**PLANNING DIVISION REPORT  
DEPARTMENT OF PLANNING AND COMMUNITY  
AND ECONOMIC DEVELOPMENT**

**October 28, 2008**

**RE: I.D. #12463, Demolition Permit – 902 Dempsey Road and 510 Cottage Grove Road**

Broken rail on exterior of Shop Building, May 2008

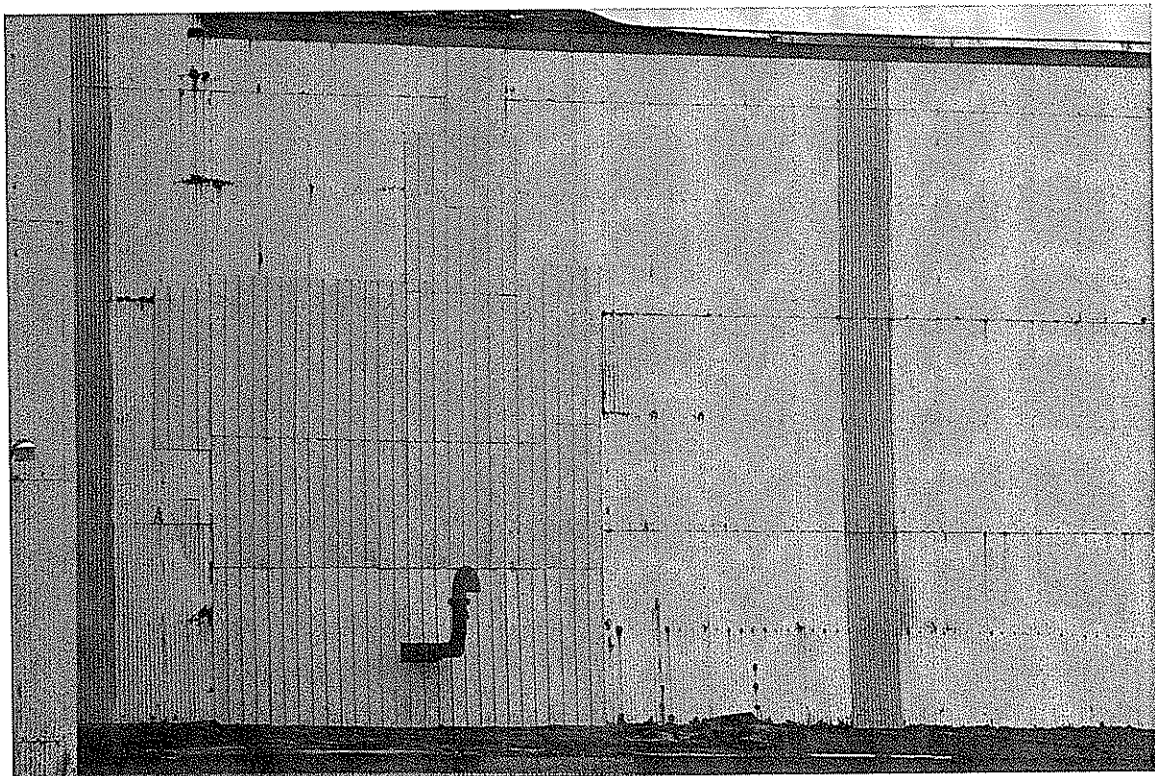
I have attached a number of pictures that show where trespassers breach the fence to enter the property and show some of the conditions of the granulation and shop buildings.

The Building Inspection Division suggests approval of the partial demolition by the Plan Commission due to the safety hazards associated with the poor condition of the buildings on the site.

Top of granulation building with graffiti, May 2008

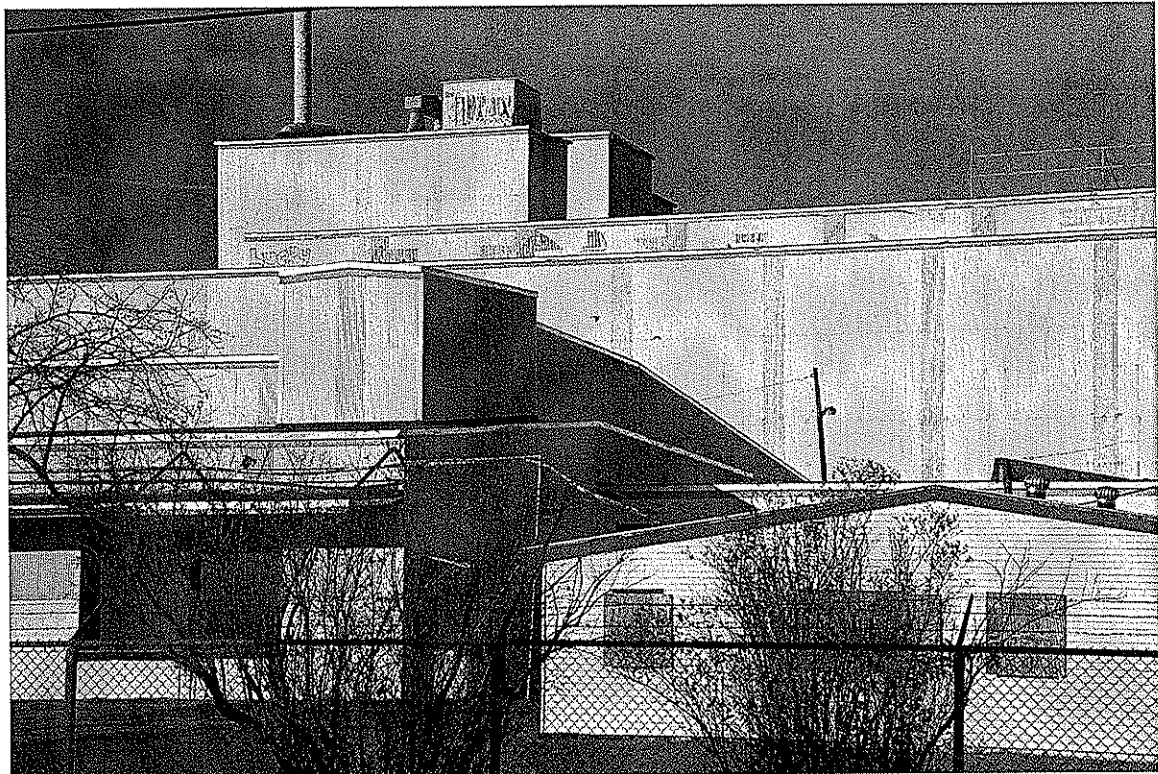
One Official Notice was issued on August 5, 2008 to remove graffiti from the granulation building by August 27, 2008. Two citations have been issued on this case and the graffiti has yet to be removed.
